TRANS/WP.29/GRSP/2000/13  
11 August 2000

PROPOSAL FOR DRAFT AMENDMENTS TO REGULATION No. 94

(Frontal collision protection)

Transmitted by the Expert from Italy

Figure 1

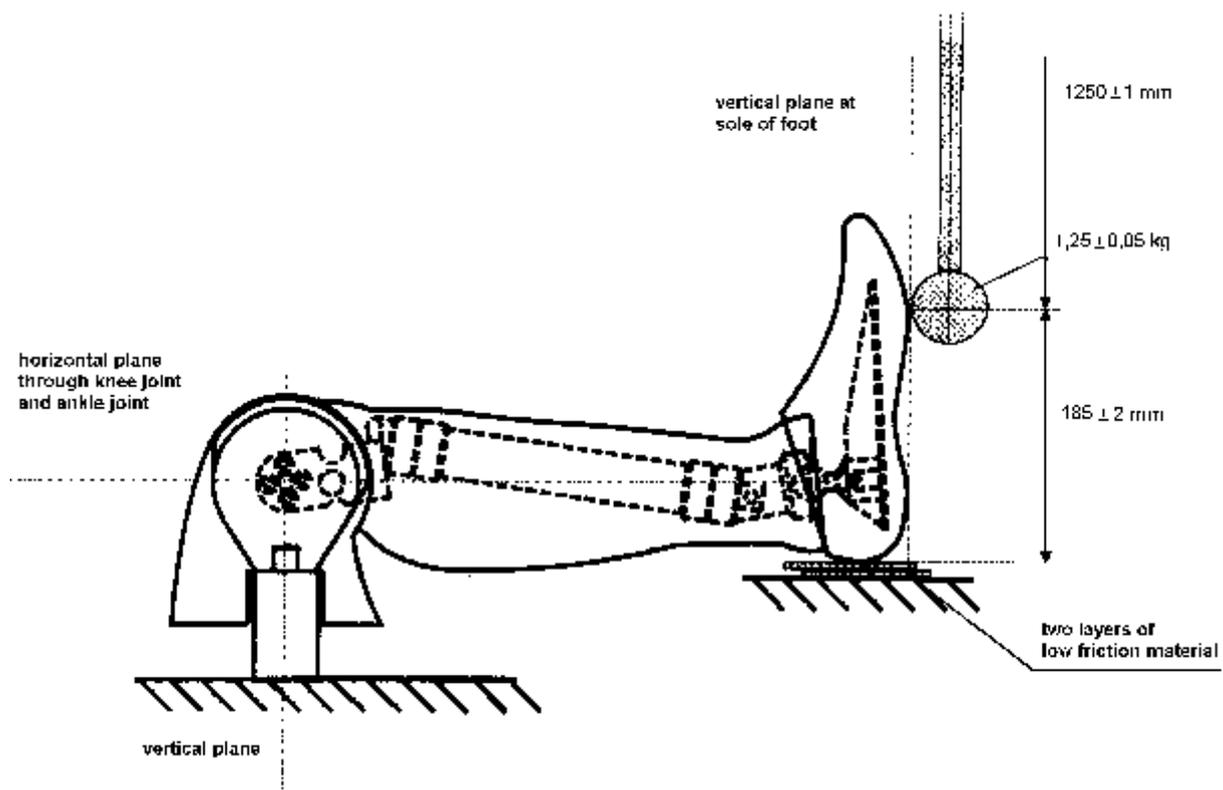
- 1.3.4. Mount the leg assembly to the fixture shown in Figure 1. The test fixture shall be rigidly secured to prevent movement during impact. The centre line of the femur load cell simulator (78051-319) shall be vertical with a tolerance of ± 0.5E. Adjust the mount such that the line joining the knee clevis joint and the ankle attachment bolt is horizontal with a tolerance of ± 3E, with the heel resting on two sheets of a flat low friction (PTFE sheet) surface. Ensure that the tibia flesh is located fully towards the knee end of the tibia. Adjust the ankle such that the plane of the underside of the foot is vertical and perpendicular to the direction of impact with a tolerance of ± 3E and such that the mid sagittal plane of the foot is aligned with the pendulum arm. Adjust the knee joint to 1.5 ± 0,5 g range before each test. Adjust the ankle joint so that it is free and then tighten just sufficiently to keep the foot stable on the PTFE sheet.

- 1.4. Performance specification
  - 1.4.1. When each ball of the foot is impacted at 6.7 (± 0.1) m/s in accordance with paragraph 1.3., the maximum lower tibia bending

momentum about the y-axis ( $M_y$ ) shall be  $120 \pm 25$  Nm.

Figure 2

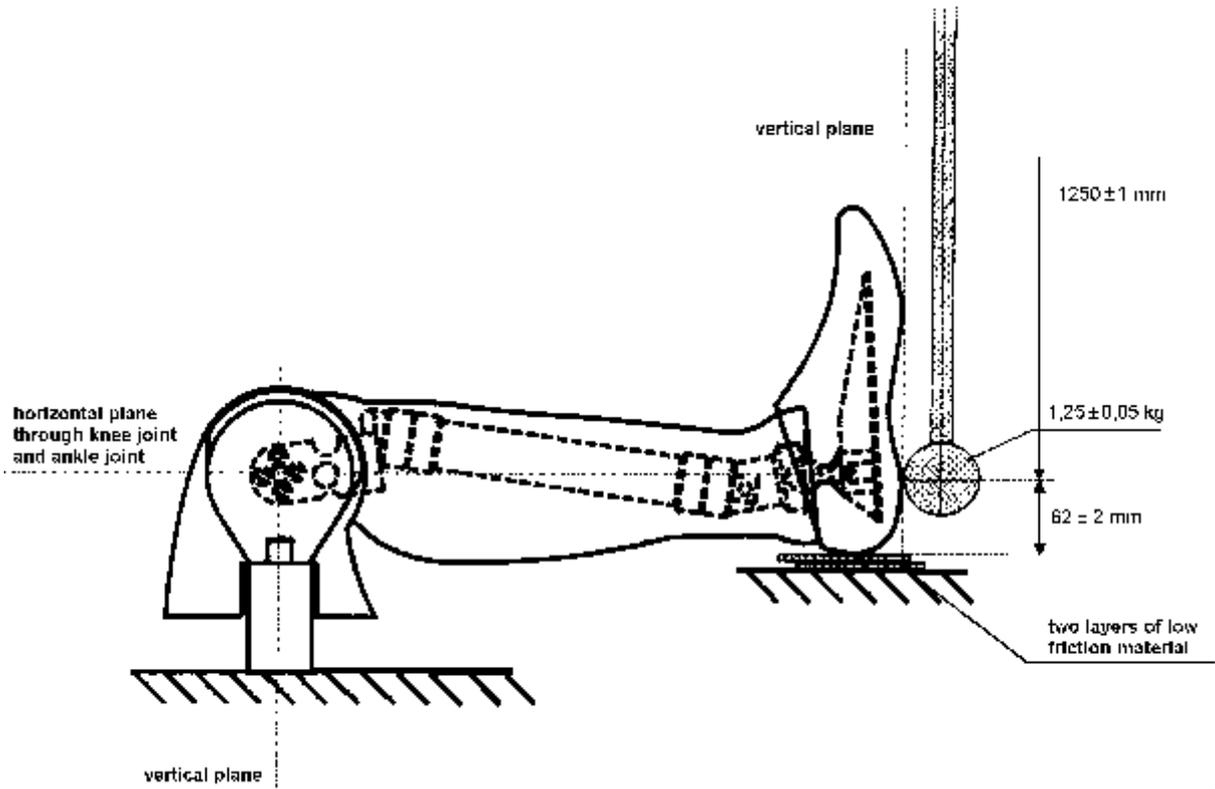
2.3.4. Mount the leg assembly to the fixture shown in Figure 2. The test fixture shall be rigidly secured to prevent movement during impact. The centre line of the femur load cell simulator (78051-319) shall be vertical with a tolerance of  $\pm 0.5^\circ$ . Adjust the mount such that the line joining the knee clevis joint and the ankle attachment bolt is horizontal with a tolerance of  $\pm 3^\circ$  with the heel resting on two sheets of a flat low friction (PTFE sheet) surface. Ensure that the tibia flesh is located fully towards the knee end of the tibia. Adjust the ankle such that the plane of the underside of the foot is vertical and perpendicular to the direction of impact and such that the mid sagittal plane of the foot is aligned with the pendulum arm. Adjust the knee joint to  $1.5 \pm 0.5$  g range before each test. Adjust the ankle joint so that it is free and then tighten just sufficiently to keep the foot stable on the PTFE sheet.

- 2.3.6. Allow a period of at least 30 minutes between successive tests on the same leg.
- 2.3.7. The data acquisition system, including transducers, shall conform to the specifications for CFC 600, as described in appendix 5 of this annex.
- 2.4. Performance specification
  - 2.4.1. When each heel of the foot is impacted at  $4.4 \pm 0.1$  m/s in accordance with paragraph 2.3., the maximum impactor acceleration shall be  $295 \pm 50$  g.

Figure 3

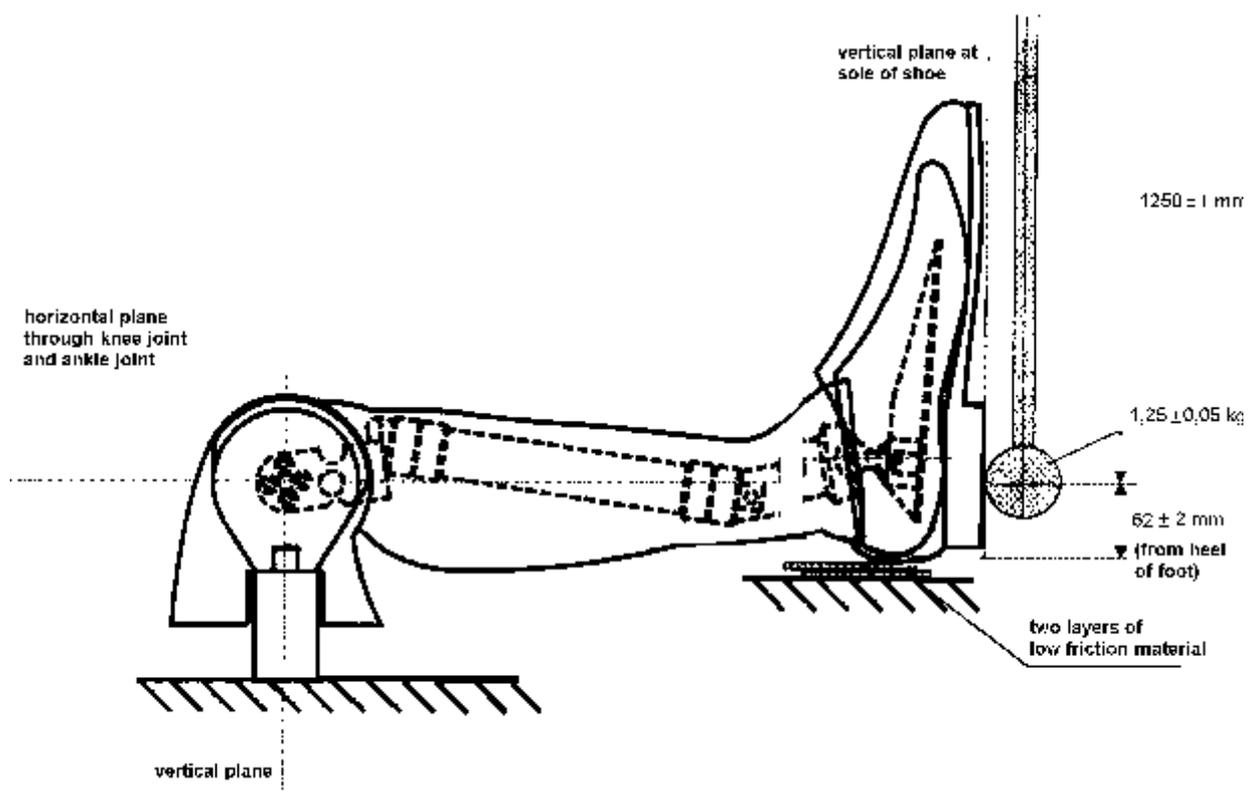
- 3.3.3. Align the impactor accelerometer with its sensitive axis parallel to the impactor longitudinal centre line.
    - 3.3.4. Mount the leg assembly to the fixture shown in Figure 3. The test fixture shall be rigidly secured to prevent movement during impact. The centre line of the femur load cell simulator (78051-319) shall be vertical with a tolerance of  $\pm 0.5^\circ$ . Adjust the mount such that the line joining the knee clevis joint and the ankle attachment bolt is horizontal with a tolerance of  $\pm 3E$ , with the heel of the shoe resting on two sheets of a flat low friction (PTFE sheet) surface. Ensure that the tibia flesh is located fully towards the knee end of the tibia. Adjust the ankle such that a plane in contact with the heel and sole of the underside of the shoe is vertical and perpendicular to the direction of impact with a tolerance of  $\pm 3E$  and such that the mid sagittal plane of the foot, and shoe is aligned with the pendulum arm. Adjust the knee joint to  $1.5 \pm 0,5$  g range before each test. Adjust the ankle joint so that it is free and then tighten just sufficiently to keep the foot stable on the PTFE sheet.

- 3.3.6. Allow a period of at least 30 minutes between successive tests on the same leg.
- 3.3.7. The data acquisition system, including transducers, shall conform to the specifications for CFC 600, as described in appendix 5 of this annex.
- 3.4. Performance specification
  - 3.4.1. When the heel of the shoe is impacted at  $6.7 \pm 0.1$  m/s in accordance with paragraph 3.3, the maximum Tibia compressive force ( $F_z$ ) shall be  $3.3 \pm 0,5$  kN.

Figure 4

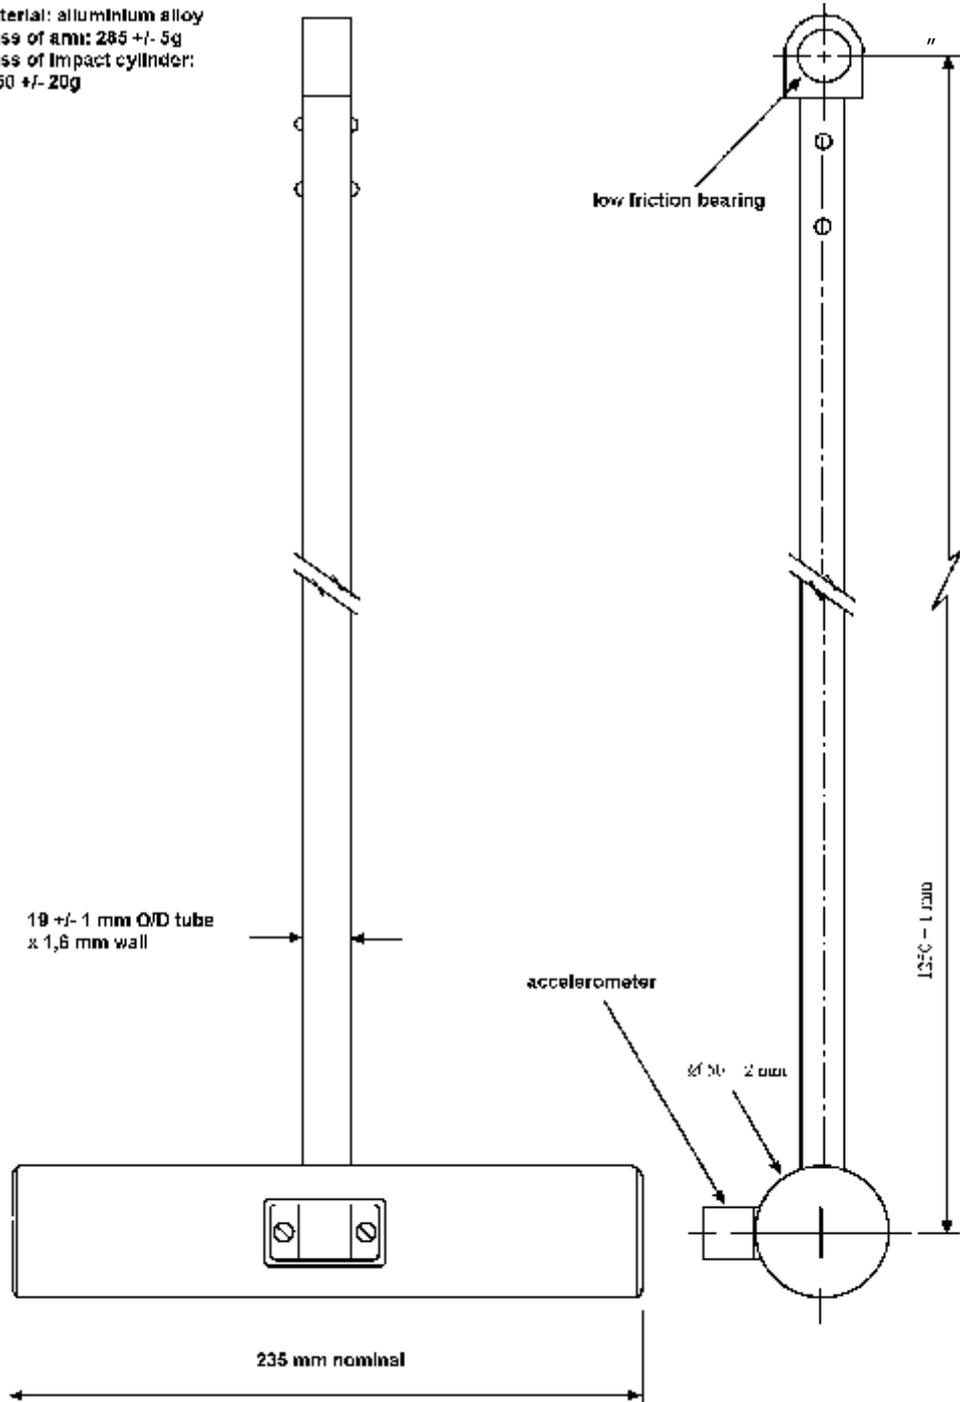
- 1.3.5. The rigid impactor comprises a horizontal cylinder diameter 50 ± 2 mm and a pendulum support arm diameter 19 ± 1 mm (Figure 4). The cylinder has a mass of 1.25 ± 0.02 kg including instrumentation and any part of the support arm within the cylinder. The pendulum arm has a mass of 285 ± 5 g. The mass of any rotating part of the axle to which the support arm is attached should not be greater than 100 g. The length between the central horizontal axis of the impactor cylinder and the axis of rotation of the whole pendulum shall be 125 ± 1 mm. The impact cylinder is mounted with its longitudinal axis horizontal and perpendicular to the direction of impact. The pendulum shall impact the underside of the foot, at a distance of 185 ± 2 mm from the base of the heel resting on the rigid horizontal platform, so that the longitudinal centre line of the pendulum arm falls within 1E of a vertical line at impact. The impactor shall be guided to exclude significant lateral, vertical or rotational movement.

2.3.5. The rigid impactor comprises a horizontal cylinder diameter  $50 \pm 2$  mm and a pendulum support arm diameter  $19 \pm 1$  mm (Figure 4). The cylinder has a mass of  $1.25 \pm 0.02$  kg including instrumentation and any part of the support arm within the cylinder. The pendulum arm has a mass of  $285 \pm 5$  g. The mass of any rotating part of the axle to which the support arm is attached should not be greater than 100 g. The length between the central horizontal axis of the impactor

- 3.3.5. The rigid impactor comprises a horizontal cylinder diameter  $50 \pm 2$  mm and a pendulum support arm diameter  $19 \pm 1$  mm (Figure 4). The cylinder has a mass of  $1.25 \pm 0.02$  kg including instrumentation and any part of the support arm within the cylinder. The pendulum arm has a mass of  $285 \pm 5$  g. The mass of any rotating part of the axle to which the support arm is attached should not be greater than 100 g. The length between the central horizontal axis of the impactor cylinder and the axis of rotation of the whole pendulum shall be
